CITY OF STOCKTON

Site Plan Review Comments for P21-0905 (1515 Fresno Av; APN: 163-370-34)

RE: Site Plan Review and Design Review Application (P22-0020) for 1515 Fresno Av; APN: 163-370-34.

DATE: AUGUST, 2022
SCALE: AS SHOWN
DESIGNER: SP
DRAWN BY: MRF
JOB NO.: A20664-1
SHEET: **2.0**
OF 3 SHEETS

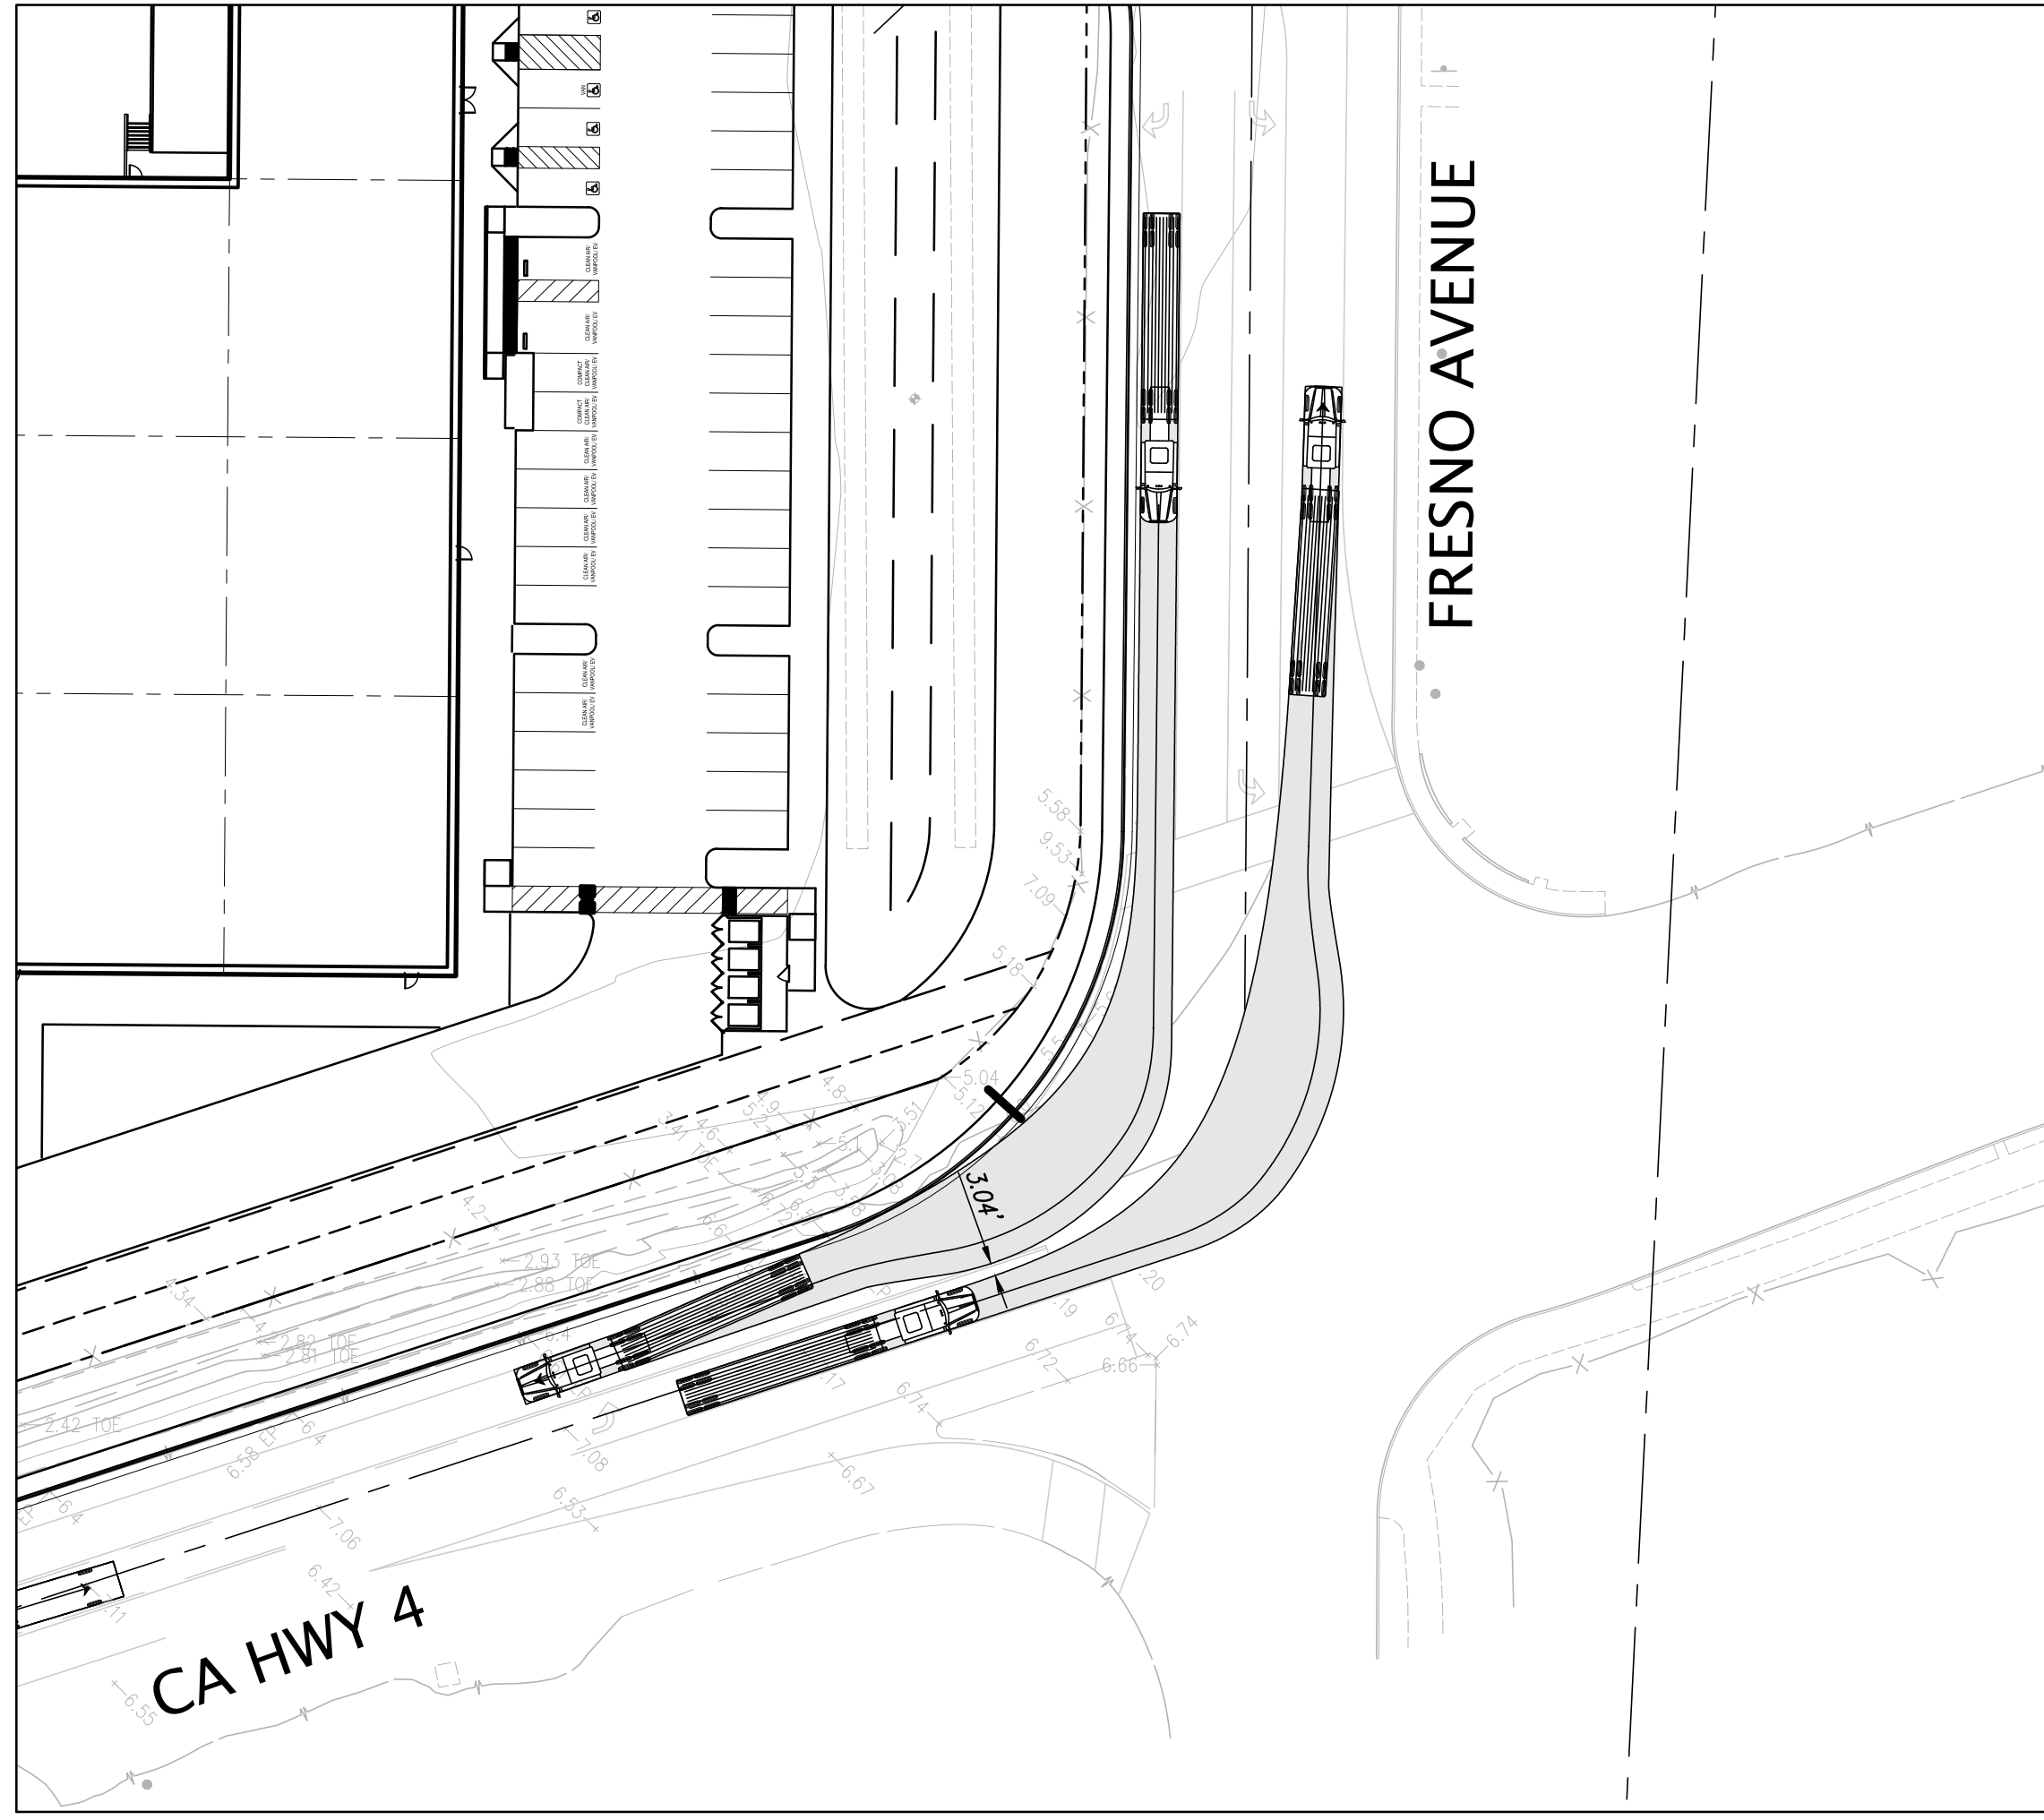
6. Prior to building permit submittal, the applicant shall revise the Fresno Avenue – Left Turn Exit and Right Turn Entrance Truck Turn diagram (Page 31 of Exhibit 1, Sheet 2.0) to indicate a 3-foot minimum distance between southbound incoming trucks and northbound outgoing trucks.

DATE	AUGUST, 2022
SCALE	AS SHOWN
DESIGNER	SP
DRAWN BY	MRF
JOB NO.	A20664-1
SHEET	3.0
OF	3 SHEETS

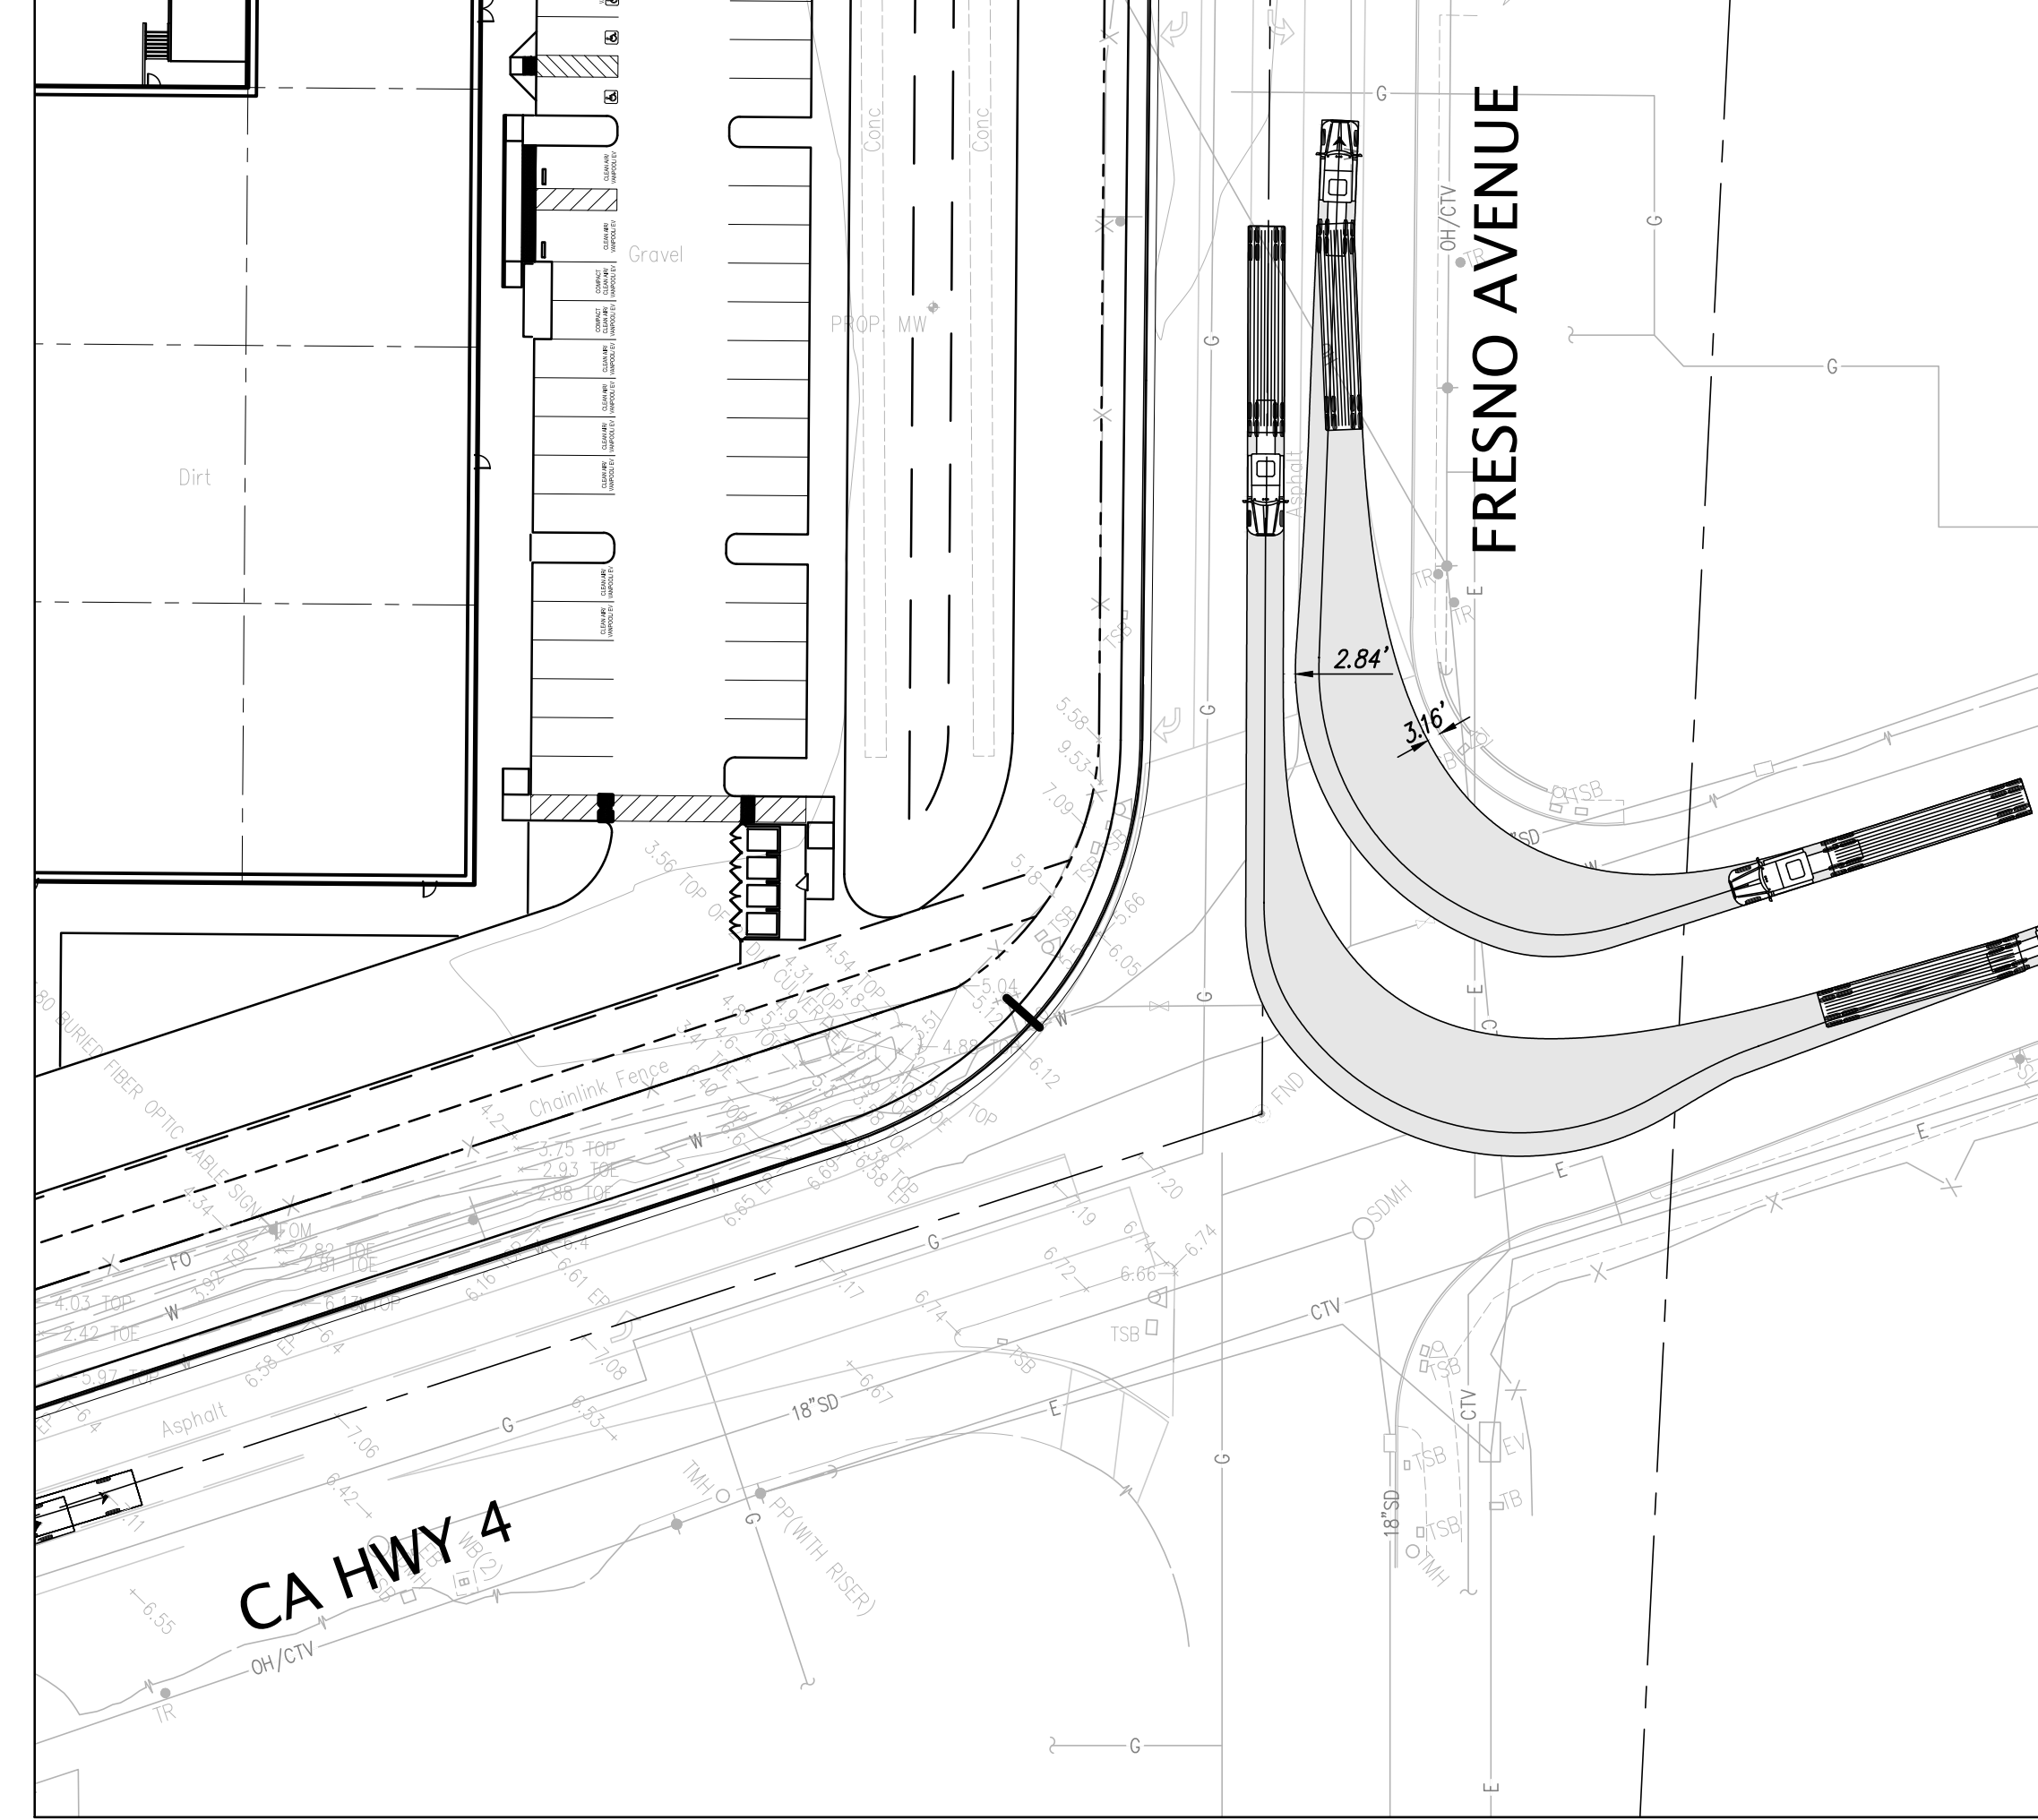
7. Prior to building permit submittal, the applicant shall revise the CA-4 Fresno Avenue Intersection NE Corner Truck Turn diagram (Page 32 of Exhibit 1, Sheet 3.0) to indicate a 3-foot minimum distance between southbound incoming trucks and northbound outgoing trucks. Note: The trucks need to turn within their designated lanes.
